**STAFF REVIEW FOR PLANNING BOARD APPROVAL
OAK RIDGE AT GRAND OAKS, SECTION II PRELIMINARY PLAT REVIEW****PROJECT HISTORY:**

The applicant is requesting approval for the Preliminary Plat of Oak Ridge Section II at Grand Oaks. The subdivision is located at off Pine Village Drive, south of Highway 210 to southwest of Rocky Point, North Carolina. The parcel is approximately 101 acres and is zoned RT, Rural Transition District. The subdivision is located on approximately 26.32 acres and will retain the same zone. The PIN is 3204-97-5209-0000.

PRELIMINARY PLAT

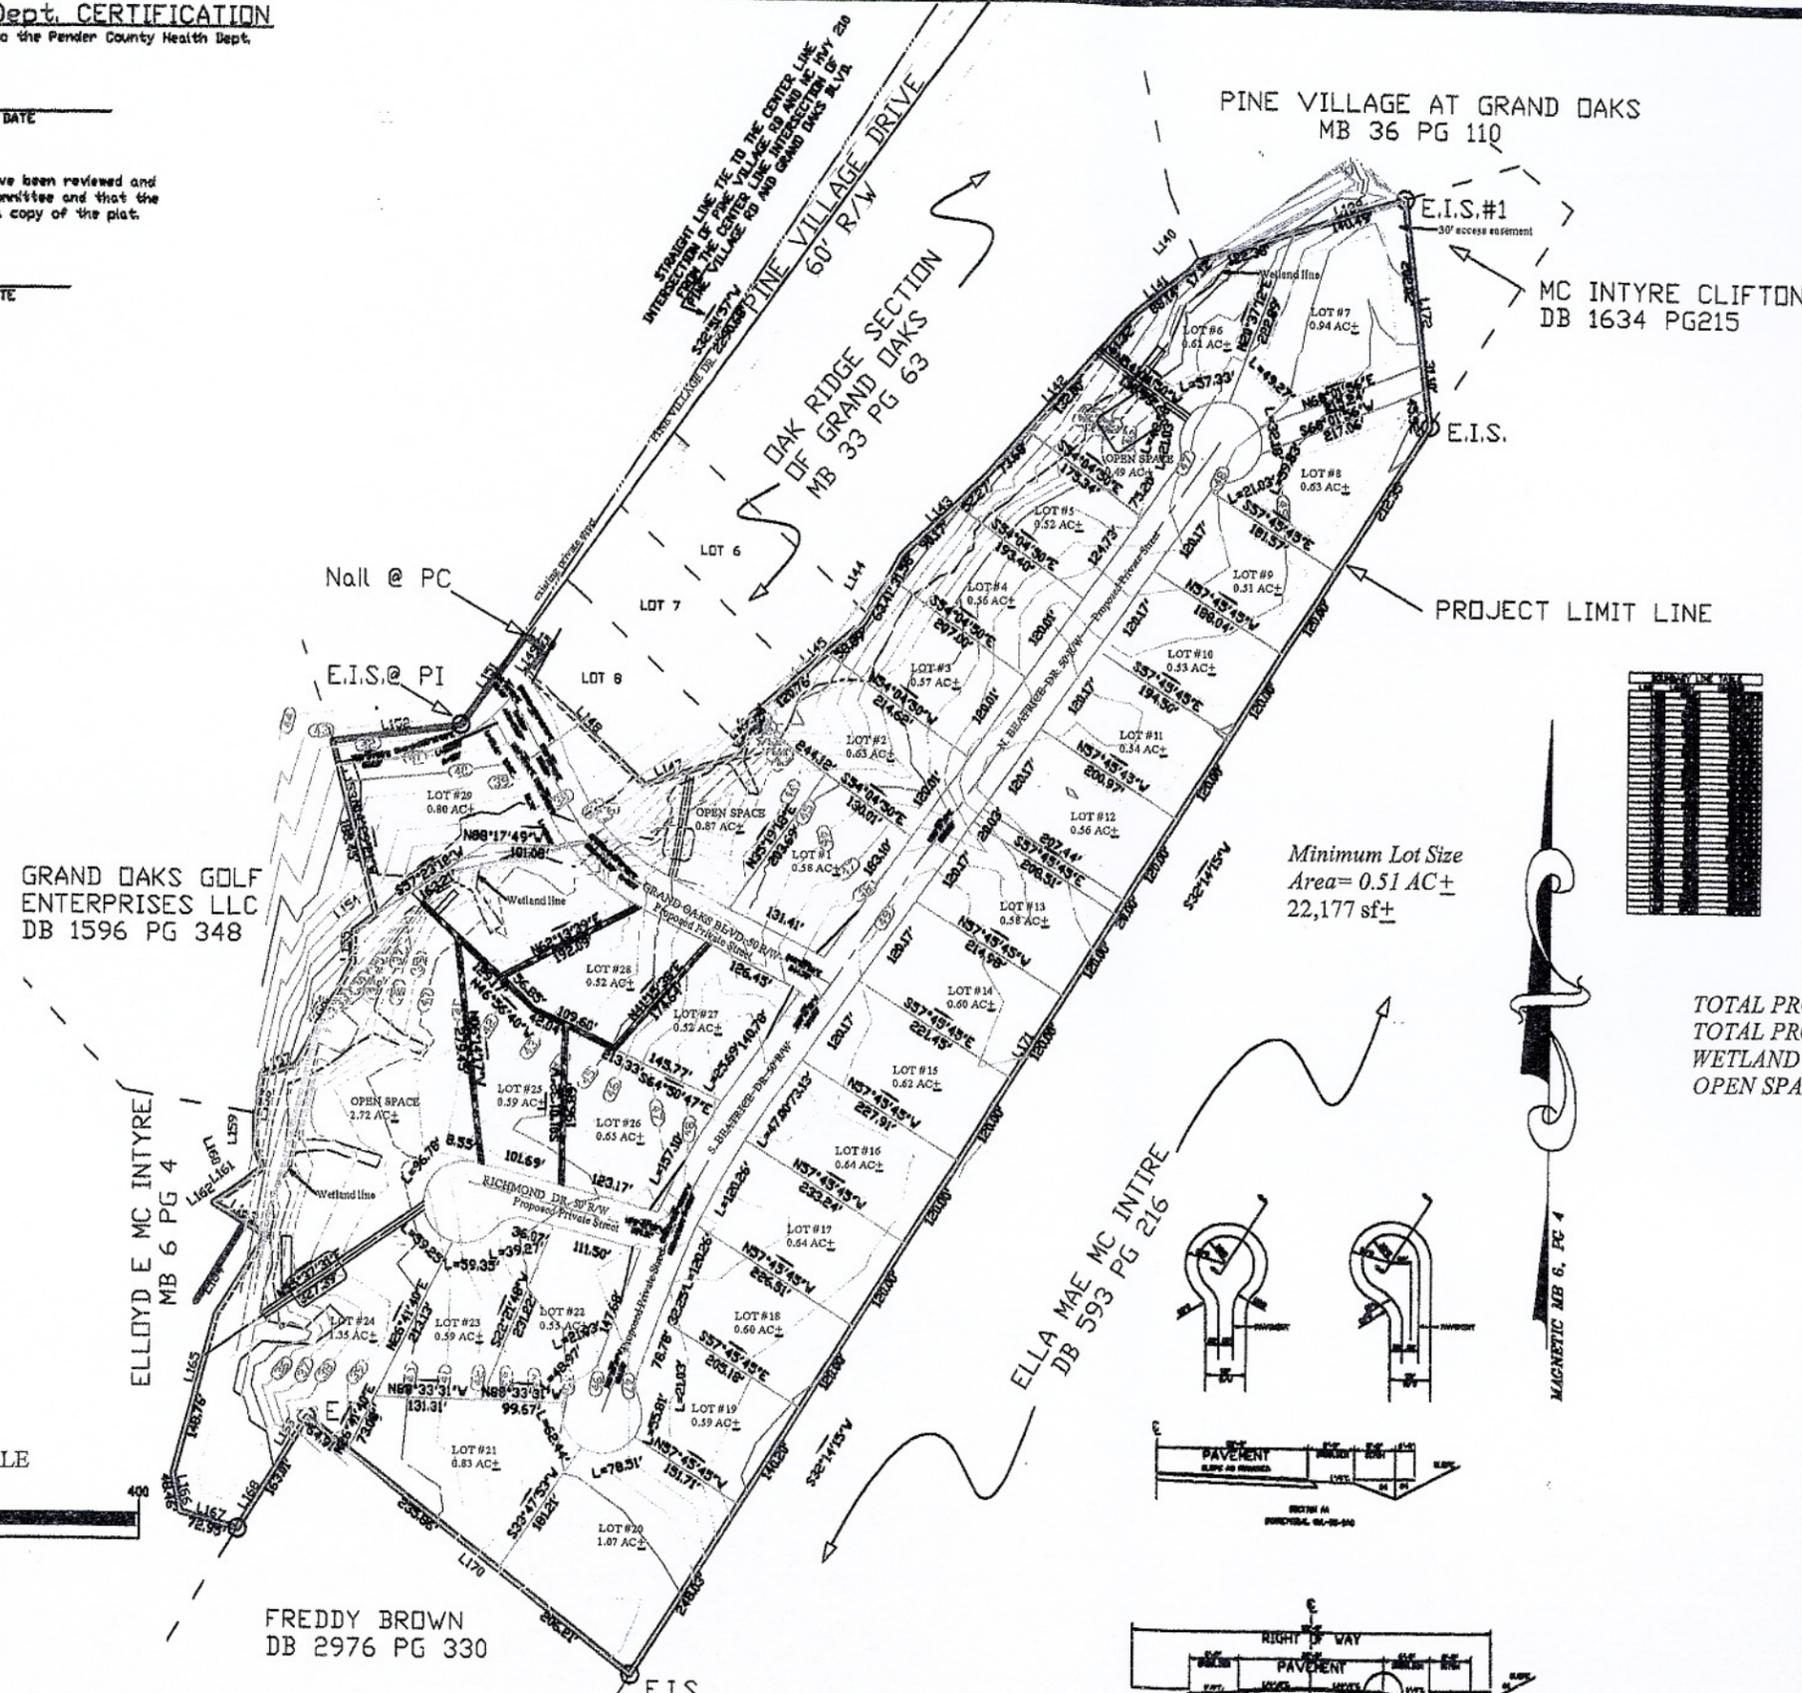
1. The submission and plat complies with all requirements of the Pender County Subdivision Ordinance, Zoning Ordinance, other Pender County Ordinances and State Regulations.

2. Total and usable lot areas and required set back lines must be shown for each lot.
3. Public Water Systems
 - (1) Constructions plans sealed by a registered engineer, as approved by DENR and Pender County Utilities Department;

5. Location of existing monuments and control points must be shown on the property.
3. The plat should clearly designate **Wetlands, Areas of Environmental Concern, CAMA Setbacks, Flood Prone Areas** (as shown on current FEMA maps), marshes, swamps, ponds, lakes, streams, and any other natural features on or affecting the site. If no Wetlands, AEC's or Flood Prone Areas exist on the site a note to that affect shall appear on the plat.

4. The plat must clearly designate Hydric Soils (Bohicket Silty Clay Loam, Carteret Fine Sand, Chewacla Loam, Croatan Muck, Dorovan Muck and Muckalee Loam) as shown on the NRCS county soil survey maps or from a Soil Suitability Analysis (required and received) prepared by a licensed Soil Scientist. If no hydric soils exist on the site a note to that affect shall appear on the plat.

5. Storm water management features must show all proposed storm water retention facilities including drainage easements, piping, culverts, swales, ditches, etc.

6. The plat must indicate the location and dimensions of existing and proposed right-of-ways & easements for utility, drainage or other facilities or structures. Easements with a width of 20' from center or 10' from the edge of all drainage facilities included on required drainage plans shall be shown for any such facilities not in public street right-of-way.
